## Two Jumpers for the AR2FS board

March 22, 2005

Instructions for the installation of two jumpers to repair bad via contacts at Location #10

### Instructions for Jumper #1 (ASDBLR side of board)

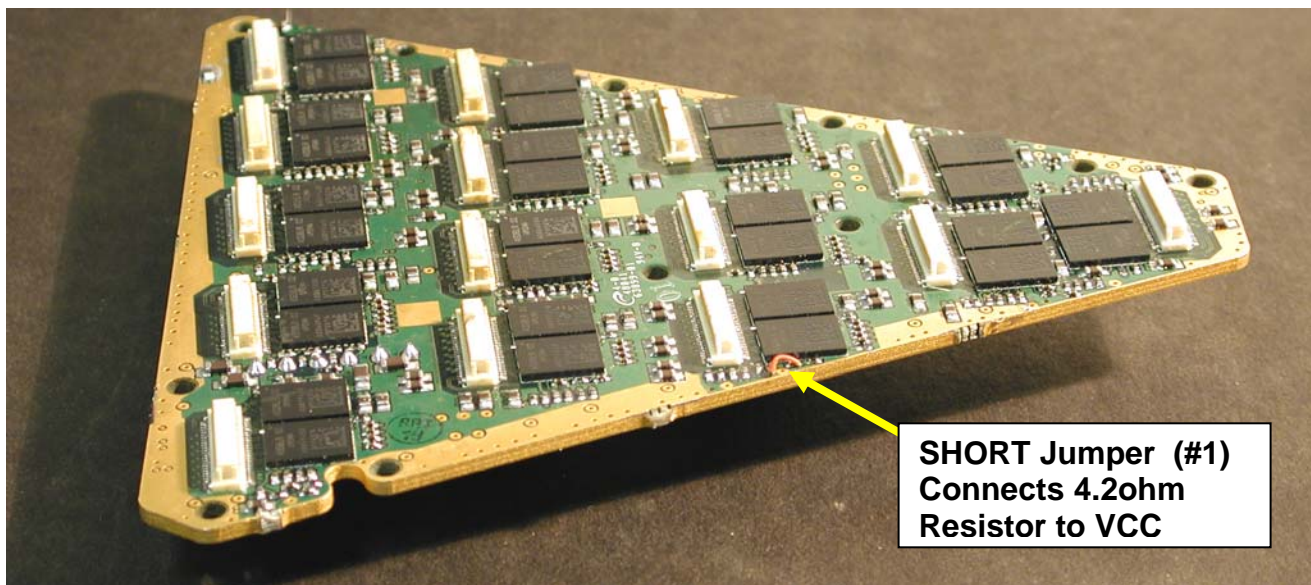
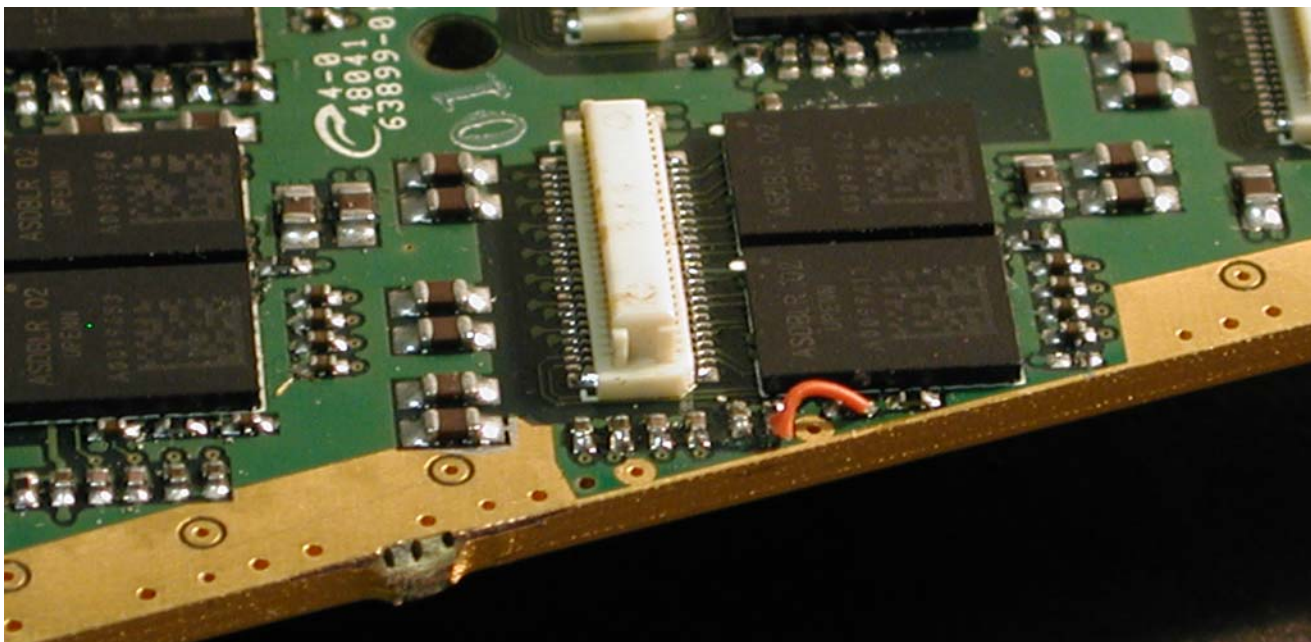
A mistake in the layout of the AR2FS board prevents the 4.7ohm preamp resistor at location #10 (DTMROC side silk screen numbering) from connecting to the Vcc supply. This is easily corrected by soldering a jumper to a nearby location. The jumper should connect between a trace that supplies +3V to an 18k resistor and a 0.1uF capacitor (See Gerber View below) and a 4.7ohm resistor as shown. It should be rated to carry at least 20mA current. For mechanical reasons 28 or 30AWG wire should be used.

The picture above shows the location of the Jumper on the AR2FS board.

## Instructinos for Jumper #2 ( also at location #10, DTMROC side)

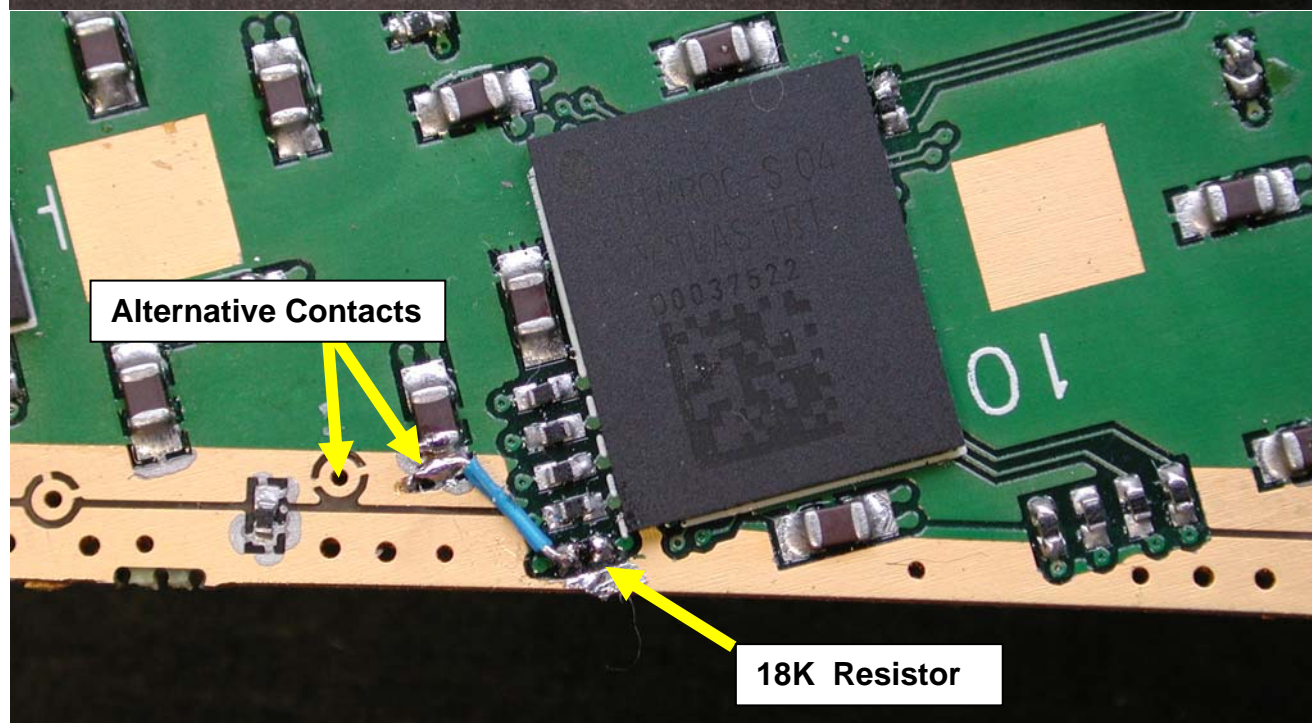
The 18k ohm resistor indicated below does not connect to digital ground (GNDD) due to a mistake in the via thermal. The jumper indicated will remedy this connection.

The picture above shows two views of the jumper installed at DTMROC location #10. The via to the right offers an alternative connection point for the connection of the jumper to Digital Ground ( GNDD).
